APPEAL SUMMARY

Appeal ID: 25044	Project Address: 3883 SW Moody Ave
Hearing Date: 8/11/21	Appellant Name: Jeancarlo Saenz
Case No.: B-003	Appellant Phone: 9727269400 x 106
Appeal Type: Building	Plans Examiner/Inspector: Maureen McCafferty
Project Type: commercial	Stories: 8 Occupancy: R-2, M, S-2, A-3 Construction Type: Type I-A & Type III-A
Building/Business Name: Block 40	Fire Sprinklers: Yes - Throughout
Appeal Involves: Erection of a new structure	LUR or Permit Application No.: 18-209390-CO
Plan Submitted Option: pdf [File 1] [File 2] [File 3]	Proposed use: Mix-use building

Appeal item 1

**Use of 2017 ICC A117.1 to address accessible electrical outlets on inside corners of kitchen counters:
Granted as proposed with accessibility to be verified at time of plan review.**

TYPICAL KITCHEN PLAN WITH INSIDE CORNER - 1/4" SCALE

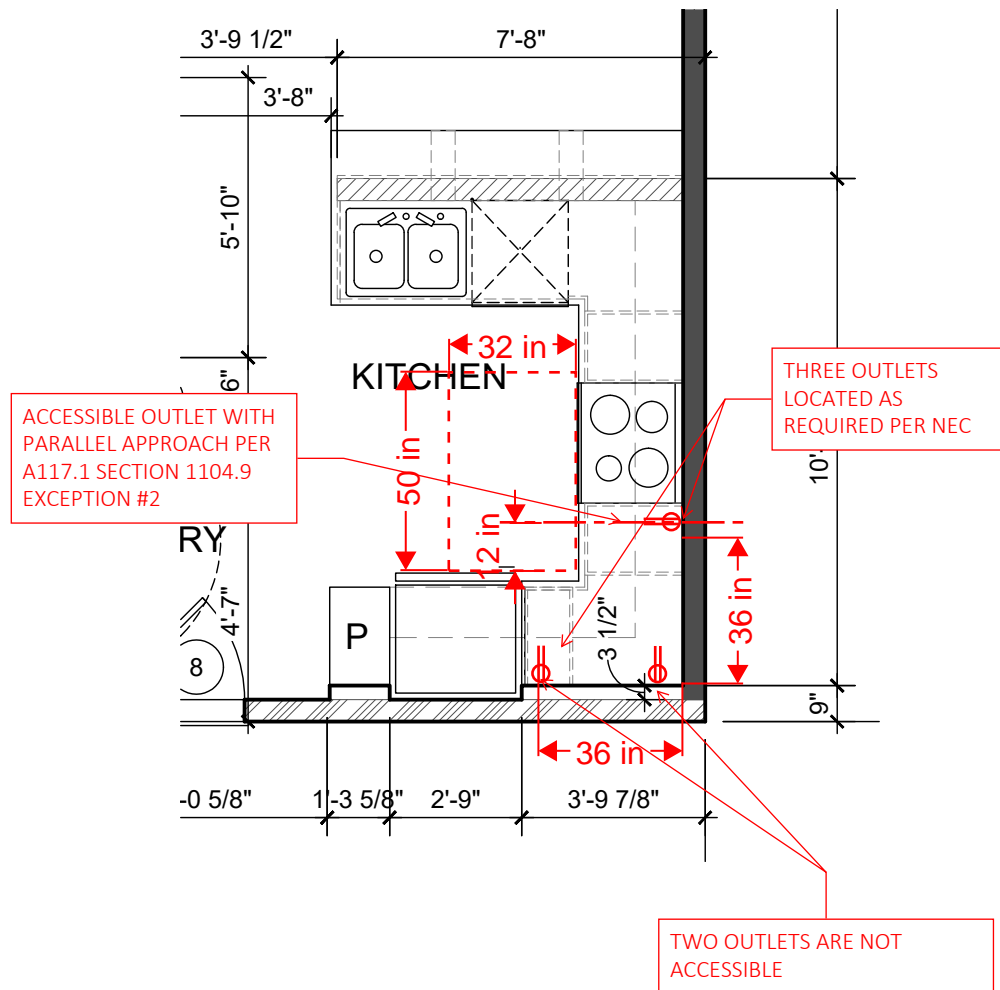
Reason for alternative	2017 ICC A117.1, 1104.9 exception #2 and #3 gives direction to the conflict between the electrical code and accessible outlets on inside corner of kitchens.

The proposed kitchen layouts won't meet electrical code and accessibility at the same time since more than 2 outlets will be required on all inside corners per section 210 of the NEC. Per this section, in kitchens, one receptacle is required over each section of counter-top with a maximum spacing of 4 feet. If an appliance or sink is located along a countertop, the counter on each side is considered a separate section, and a receptacle must be installed on each side.

Because the inside corner is flanked by two appliances, it is considered a counter-top and outlets need to be located at the spacing required. On inside corners, the length of the surface is longer than usual, which generates the requirement for more than 2 outlets to comply with the electrical code. This is the case for some of the kitchens in this project and the reason for the request of an alternate design.

The proposed kitchen layouts do provide an accessible reach to one outlet at a minimum, as outlined in exception #2 (see attached diagram). This solves the conflict generated by the NEC.

This design only affects Type B units, all requirements for Type A units still meet the provisions of 2009 ICC A117.1. Also, the design approach provided by the 2017 ICC A117.1 for electrical outlets in kitchens is also consistent with what is required by the Fair Housing Act, which is listed on section 1101.2.1 as alternate method of design.
